APPLICATION FOR A SITE EVALUATION FOR AN ON-SITE

WASTEWATER TEATMENT SYSTEM Fax: 406.447.8398 du also permit 14862 NO CONSTRUCTION of dwellings, domestic wells, or septic systems shall take place until: 1) this site evaluation is complete Fee Paid 2000 and 2) a numbered septic permit is issued for this system by the Lewis and Clark City-County Health Department. Receipt # 1004// If any construction occurs prior to a permit being issued, the permit fee will be doubled and additional civil administrative penalty fees may be charged. Fee for site evaluation only: **OFFICE USE** Add'l Time charged New Site \$300/per system DATE TIME Existing Field Replacement \$300/per system Review of Existing System \$300/per system Has the existing system failed or malfunctioned? No Is there surfacing sewage? No Property Owner Jenn: fer Krause & Julie Krause Property Address 3210 Euclid Installer Jim Webber (CI) NC Phone 443-3807 Treatment system to serve: Residential Commercial Other V Group Home Total Living Space 5,000 square feet and 8 number of bedrooms - we will put in

3	
PROPERTY OWNER	Jennifer and Julie Krause
PROPERTY ADDRESS	3210 Euclid / 3203 Broadwater

REVIEWED BY: Frank Preskar, R.S.

3210Euclid / 3203 Broadwater

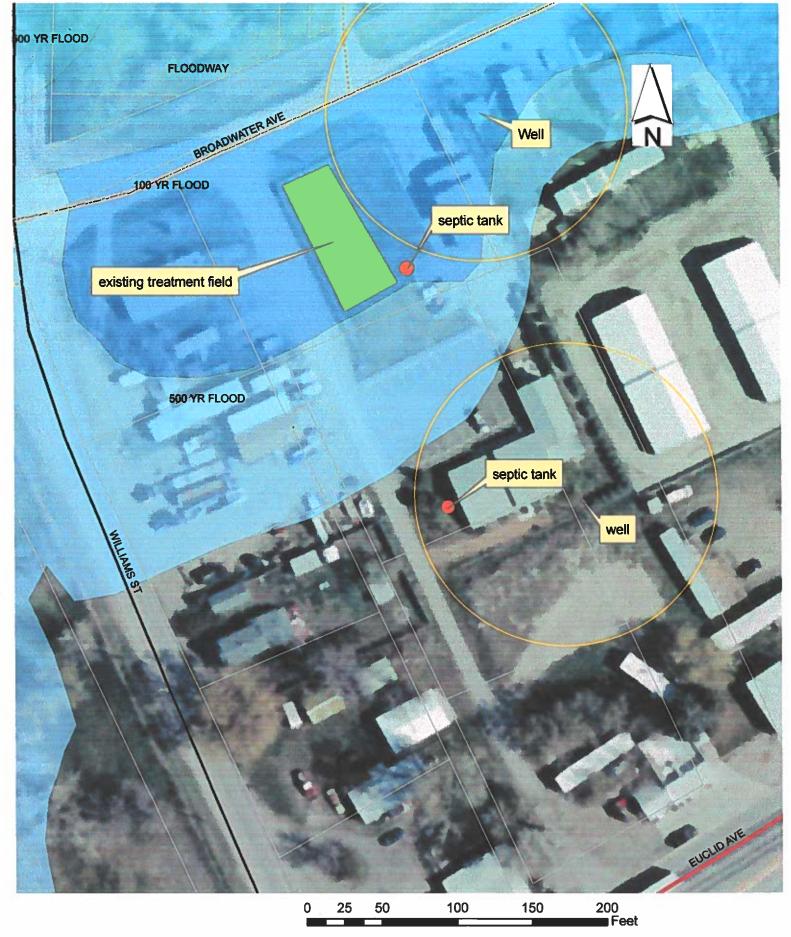
100 gollons perdy per Bed X8 = 800 gollons/dex 15 gollons perdy per employee X8 = 120 gollons/dex 920

rexisting system = 580 linearfeet gravity treatmentfield

6 Bels x 100gpd = 600gpd # Stiff x 15 gpd = 60 gpd 660gpd

> 920 + 660 - 1580 gpd Total -

J 580 linear fret 2'wide grevity trench
approte = 0.6? not known, No tost git info
Total coposity = 696 gpd
